INDESIT company

Model type:
CDE129ALL/HA

Commercial code:
F051811

Notices

n4008f00: Thermic link wire removed on three-phase motor

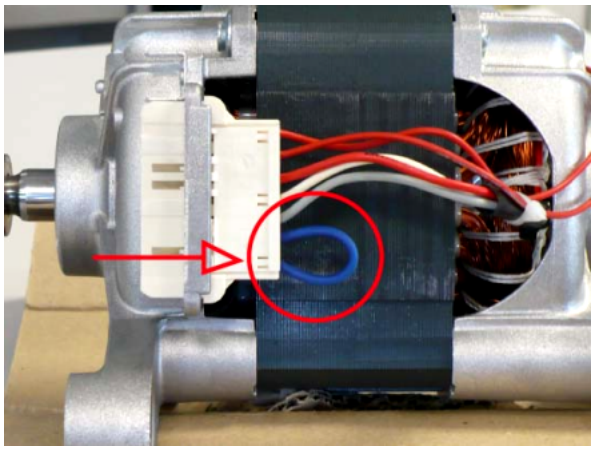
Attention!
When you assist the premodification models using the new motor code you MUST use the thermic link wire code C00265838.

The spare part warehouses will manage the premodification motor until the end of the stock, after they will be replaced with new ones and thermic link wire.

In the attached image you can see the fixing of thermic link wire in the motor therminal box.
